HISTORIC AND DESIGN REVIEW COMMISSION

Agenda Item No: 18

HDRC CASE NO: 2015-237
ADDRESS: 510 ADAMS ST
LEGAL DESCRIPTION: NCB 2914 BLK 3 LOT 3
ZONING: RM4 H
CITY COUNCIL DIST.: 1
DISTRICT: King William Historic District
APPLICANT: Juan Barrera
OWNER: Juan & Romanita Barrera
TYPE OF WORK: Addition and rehabilitation
REQUEST:

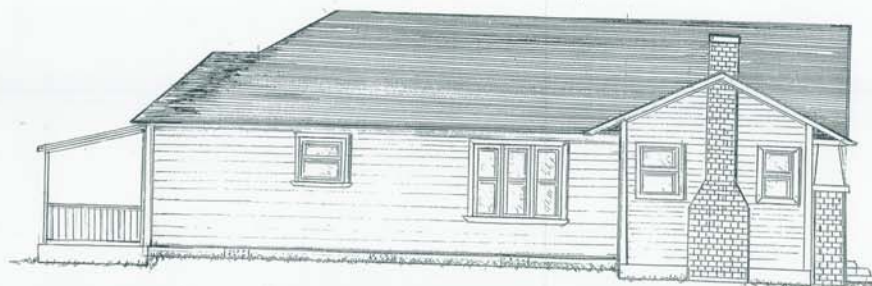
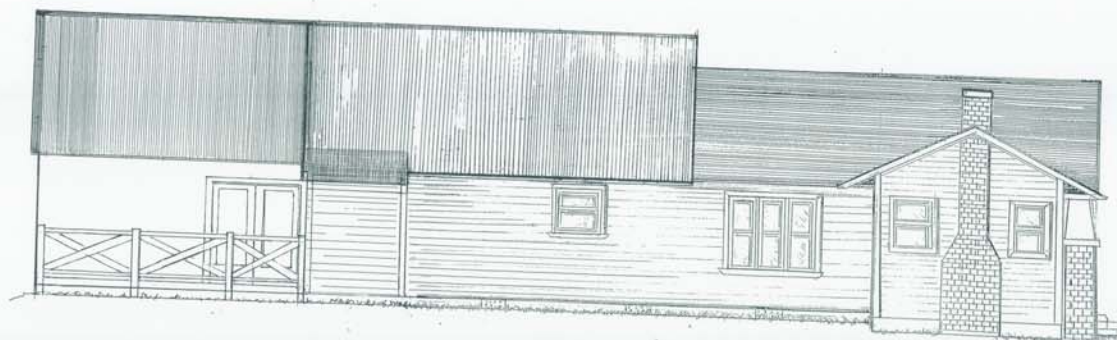
- g. The applicant has proposed for the ridge height of the proposed addition to be slightly taller than that of the existing structure. This is not consistent with the Guidelines for Additions 1.B.v. Staff recommends that the applicant reduce the height of the addition's ridgeline to a height shorter than that of the existing structure to become consistent with the Guidelines.

- i. That any wood windows that are removed to accommodate the proposed addition be restored and used in the new addition.
- ii. That the applicant reduce the height of the addition's ridgeline to a height shorter than that of the existing structure to become consistent with the Guidelines.

EAST SIDE Porch

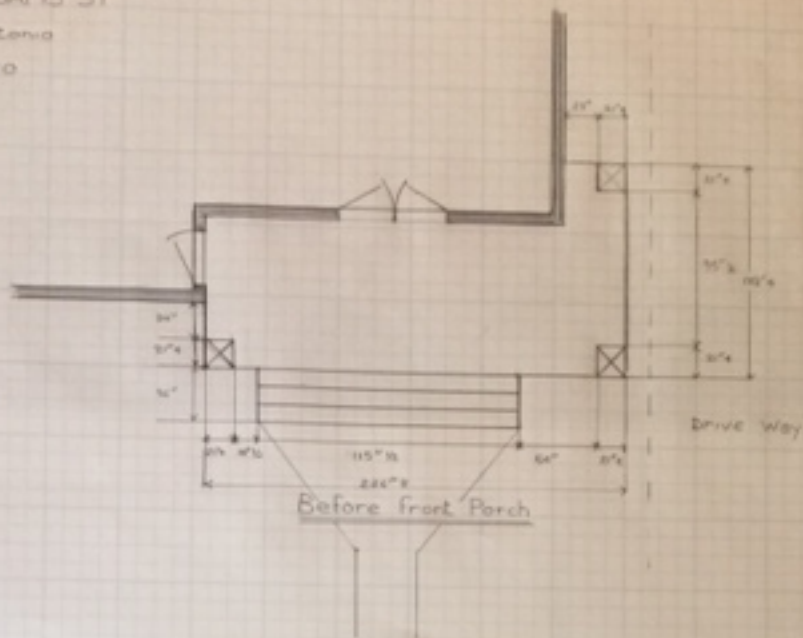
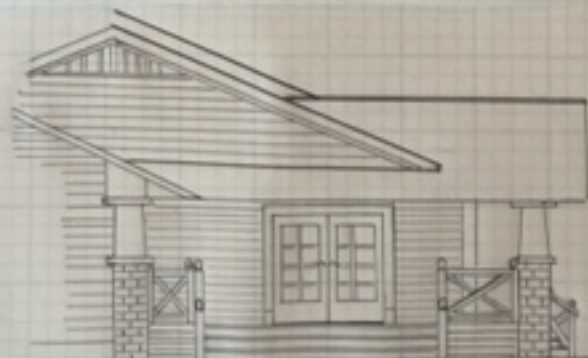
- j. The applicant has proposed to demolish the existing concrete porch and reconstruct it with wood, matching the existing additions. The applicant has also proposed wood handrails, but at this time has not provided staff with \ information regarding the proposed handrails. The Guidelines for Exterior Maintenance and Alterations 7.A.iii. states that original wood or concrete porch floors should be preserved. In this particular case, this structure would have historically featured a concrete front porch as do a majority on this block of Adams. If the existing concrete porch is structurally unsound, the applicant should repair in kind.

Staff does not recommend approval of item #5 based on finding j. If the existing concrete porch must be replaced, staff recommends that the applicant replace in kind. Additionally, if front porch railings are requested, the applicant should provide the proper architectural documents for that specific scope of work.
